Changes to Clause 85 due to comment #64

Changes to Clause 86A due to comment #63

**Figure 86A-4—Return loss limits of mated HCB-MCB**

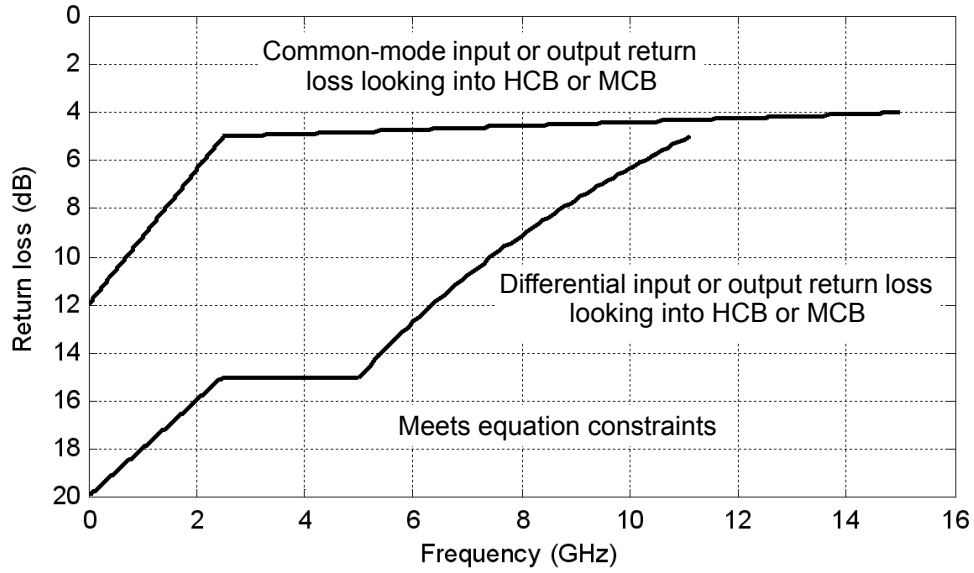
The limit on the common-mode return loss in decibels of the mated HCB and MCB is given in Equation (86A-8) and illustrated in Figure 86A-4.

$$Return\_loss(f) \geq \begin{cases} 12 - 2.8f & 0.01 \leq f < 2.5 \\ 5.2 - 0.08f & 2.5 \leq f \leq 15 \end{cases} \text{ dF} \quad (86A-8)$$
